# Amendments to the Inertia Requirements Methodology

Draft Report – Standard consultation  
for the National Electricity Market

**Published: 25 September 2024**

**Figure 2 AEMO’s proposed high level overview of assessment methodology for system-wide inertia levels**

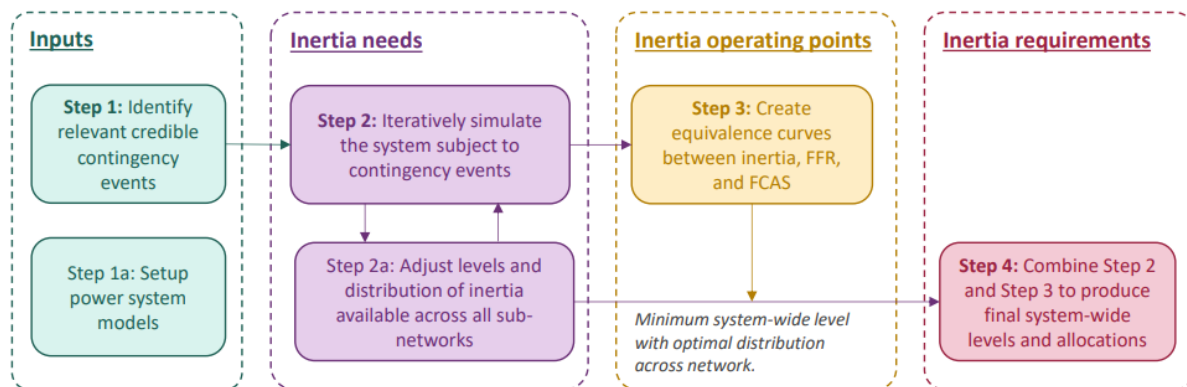
**Shell Energy**, whilst supportive of Step 1 and 2 in Figure 2 below, expressed concerns that it is "unclear what Step 2a would mean in practice". **Shell Energy** also voiced concerns over AEMO's proposed modelling approach, noting the "high risk that the development of the system does not align with modelled requirements over the 10 year horizon which could lead to substantial levels of inefficient investment". **Shell Energy** further recommended that AEMO consider how "the location of inertia services could result in different frequency oscillation modes at a system-wide level".

AEMO has modified its approach in this draft determination from the approach proposed step 2a of the consultation paper to vary the distribution of inertia in each inertia sub-network when calculating the system-wide inertia requirements. Step 3) in section 4.6 of the Draft Inertia Requirements Methodology published with this report specifies that the inertia distribution across inertia sub-networks will be determined by the islanded
